Access Compliance Report

Public Rights-of-Way

(Curb Ramps)

Intersection ID: N/A	Main Street: YORK_CENTER	Cross Street: N/A	Location:	E
ADA ID: 51BB7035C8D3	Ramp Type: PerpDiag	Initial Pass/Fail: Fail	Overall Compliance: No	Severity Score: 60
Codes/Mitigation Info/Possible Solution		Field Measurements/Component Compliance

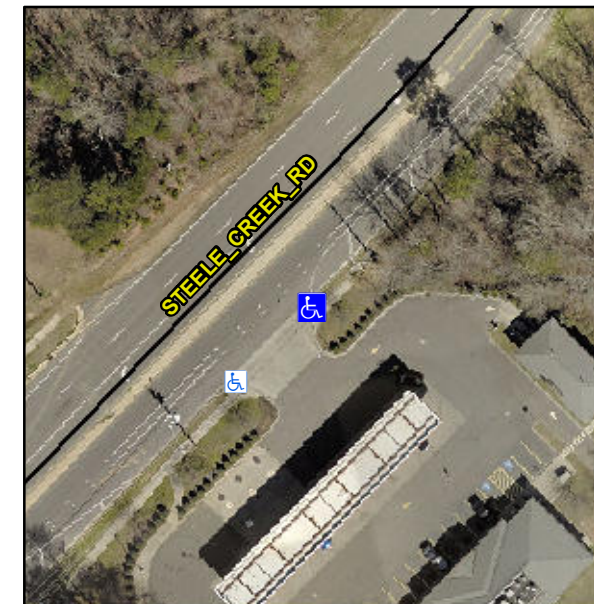
Not Found, R304.5.1, R304.5.3

Compliance	Description	Data	Compliance	Description	Data
N/A	Ramp Length (in)	61.0	Yes	Ramp Slope (%)	7.1
No	Ramp Width (in)	25.0	No	Ramp XSlope (%)	9.4
N/A	Flare Type LT	N/A	N/A	Flare Type RT	N/A
N/A	Flare Slope LT (%)	N/A	N/A	Flare Slope RT (%)	N/A
N/A	Flare Traversable LT?	N/A	N/A	Flare Traversable RT?	N/A
N/A	Landing Length (in)	N/A	N/A	DWS Provided?	N/A
N/A	Landing Width (in)	N/A	N/A	DWS Contrast?	N/A
N/A	Landing Slope (%)	N/A	N/A	DWS Length (in)	N/A
N/A	Landing X Slope (%)	N/A	N/A	DWS Full Width?	N/A
N/A	Landing Curb? (Y/N)	N/A	N/A	DWS Offset (in)	N/A
N/A	Shared Landing?	N/A			
N/A	Gutter Ponding?	N/A	N/A	Gutter Slope (%)	N/A
N/A	Gutter Lip Ht (in)	N/A	N/A	Gutter X Slope (%)	N/A
N/A	Painted X Walk1?	No	N/A	Painted X Walk2?	No
	X Walk 1 Direction	To W		X Walk 2 Direction	To S
N/A	X Walk 1 Width (in)	N/A	N/A	X Walk 2 Width (in)	N/A
	X Walk 1 Slope (%)	7.2		X Walk 2 Slope (%)	1.8
	X Walk 1 X Slope (%)	0.8		X Walk 2 X Slope (%)	7.8

Remove & Replace Curb Ramp With Two New Directional Ramps or Equivalent.
